RESPONSE TO REQUEST FOR ADDITIONAL INFORMATION

APR1400 Design Certification

RAI No.: 357-8344
SRP Section: 06.02.04 - Containment Isolation System
Application Section: Section 6.2.4
Date of RAI Issue: 01/05/2016

Question No. 06.02.04-4

Figure 9.2.2-1 Component Cooling Water System Flow Diagram (1 of 4)

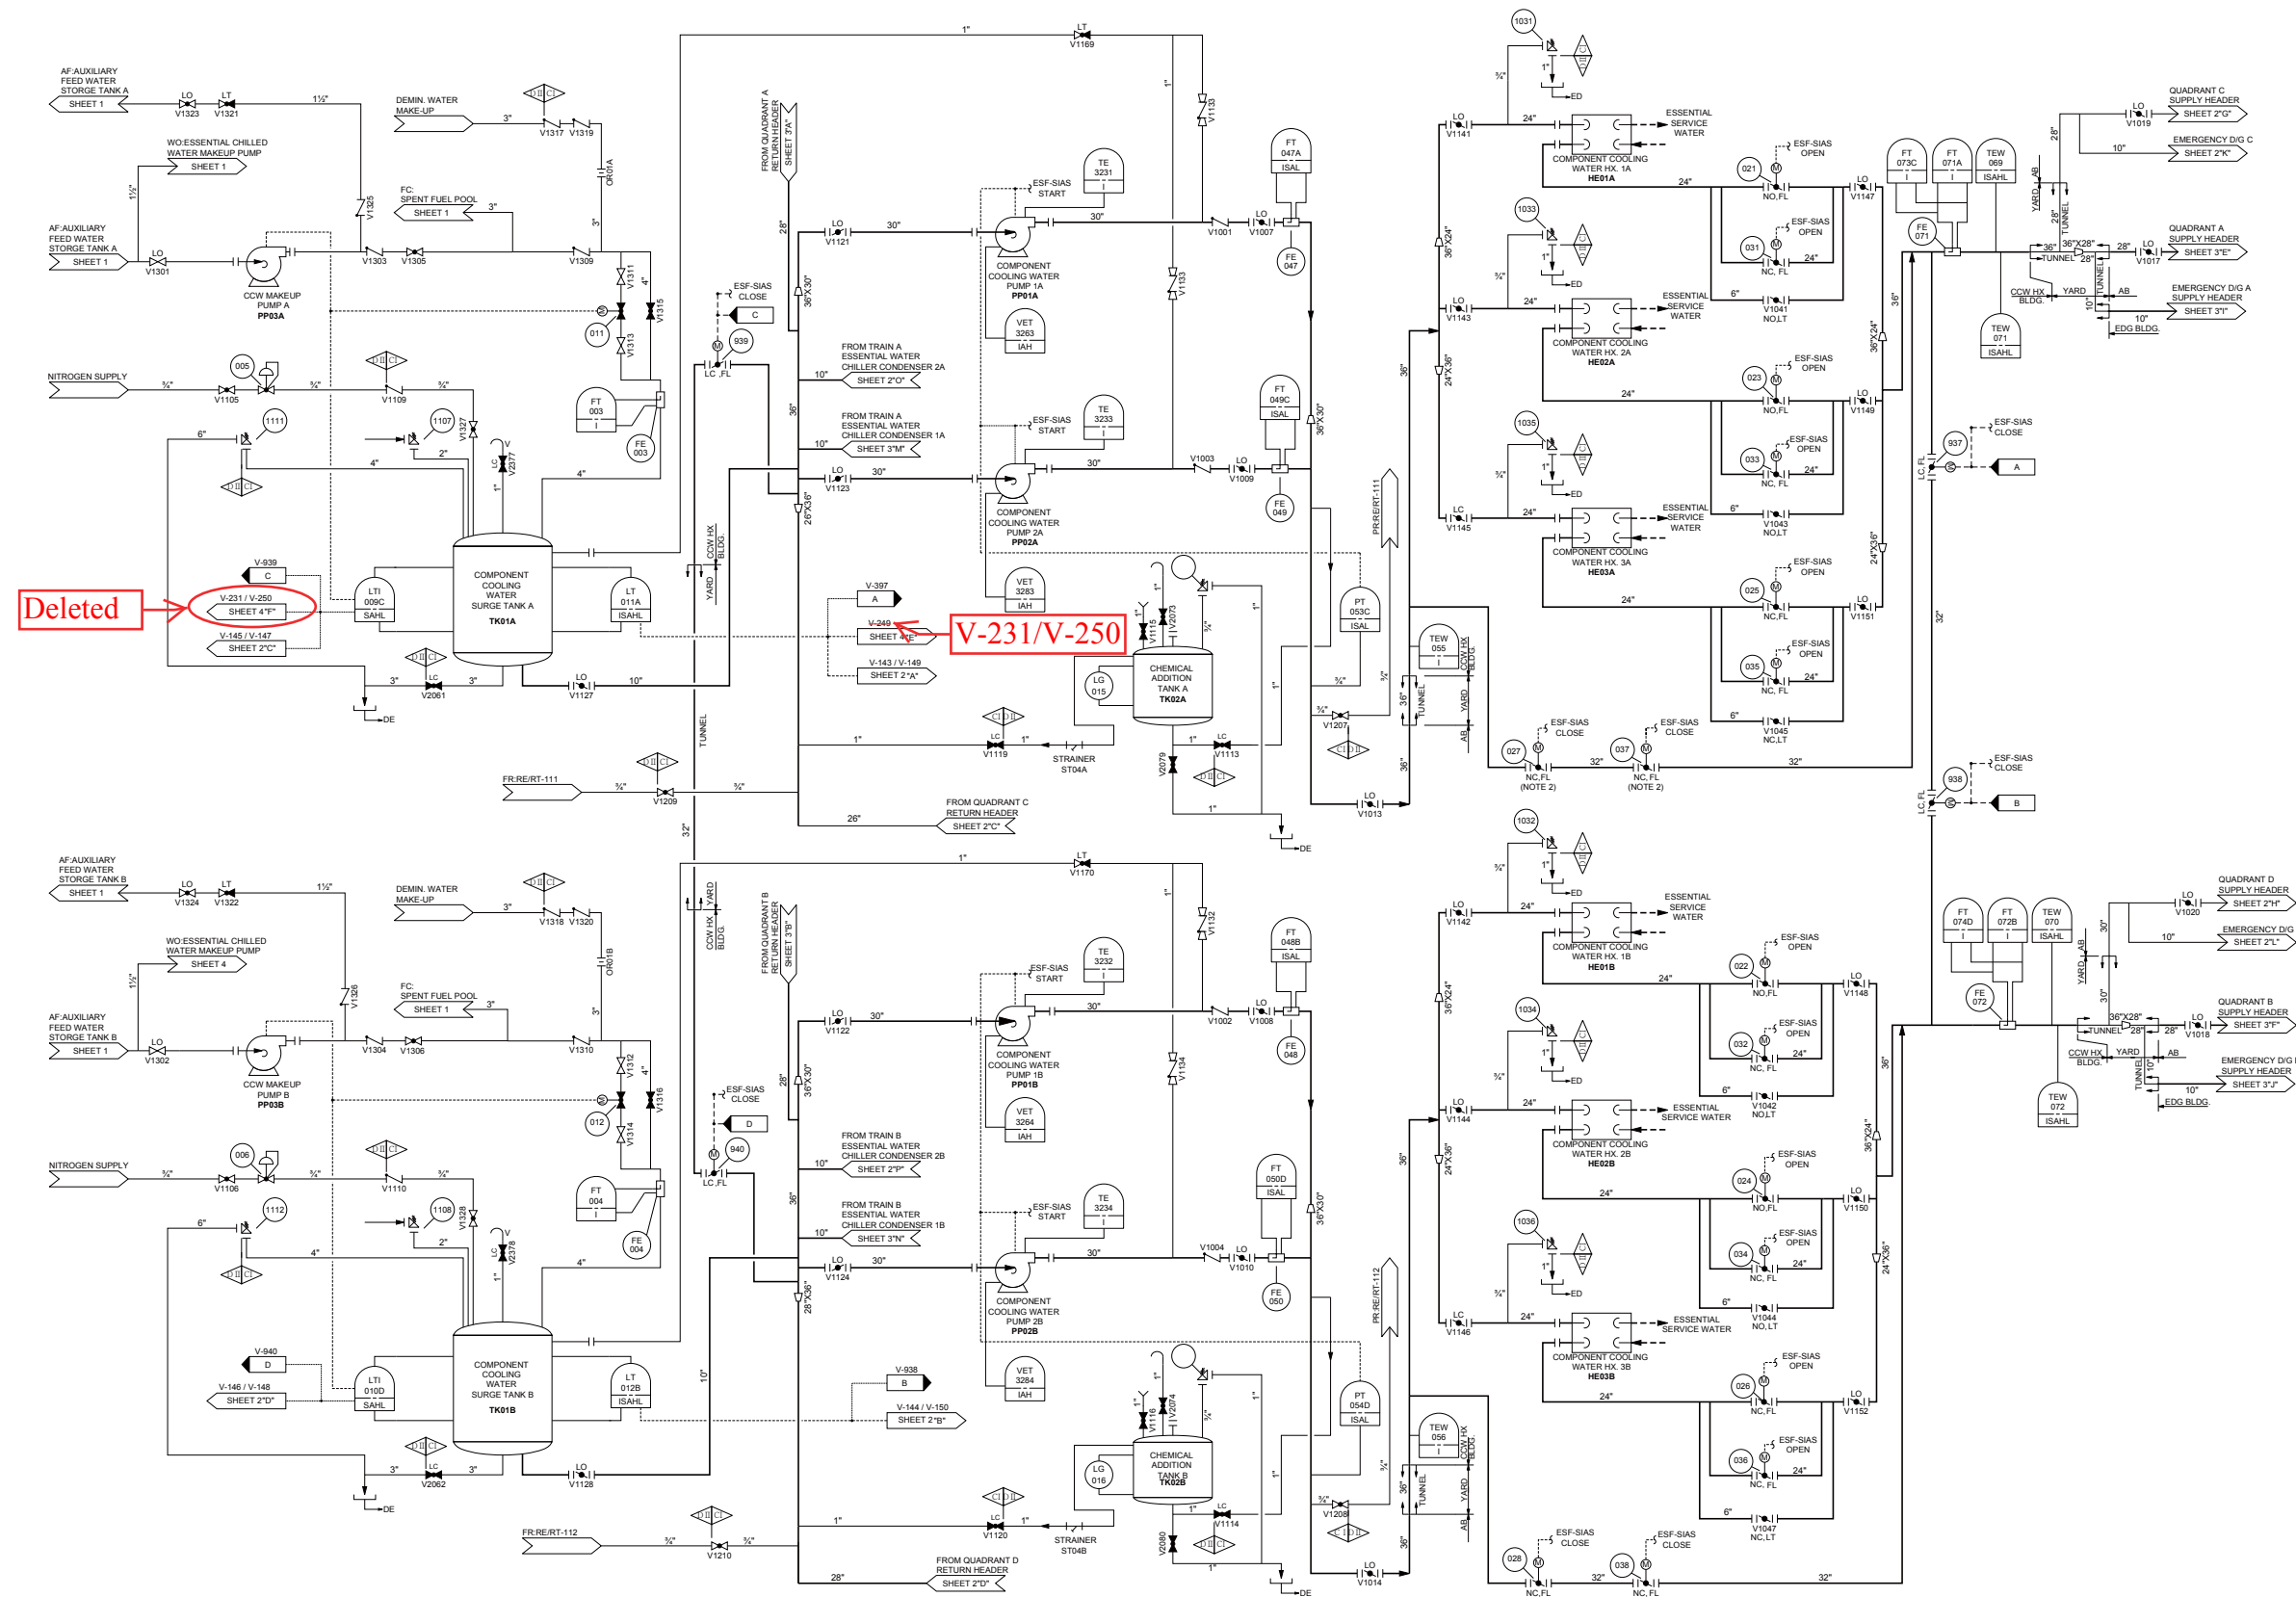
In addition, Table 9.2.2-6 and Figure 9.2.2-1 will be revised to correct the power segregation for Valves CC-231, 249, and 250.

CCWS Motor-Operated Valves (Cont'd)	
Valve	Train
CC-V-0143	A
CC-V-0144	B
CC-V-0145	C
CC-V-0146	D
CC-V-0147	C
CC-V-0148	D
CC-V-0149	A
CC-V-0150	B
CC-V-0181	C
CC-V-0182	D
CC-V-0191	A
CC-V-0192	B
CC-V-0231	€ ← A
CC-V-0249	A ← B
CC-V-0250	€ ← A
CC-V-0296	A
CC-V-0297	B
CC-V-0301	B
CC-V-0302	A
CC-V-0351	A
CC-V-0352	B
CC-V-0383	A
CC-V-0384	B
CC-V-0389	A
CC-V-0390	B
CC-V-0937	A
CC-V-0938	B
CC-V-0939	C
CC-V-0940	D
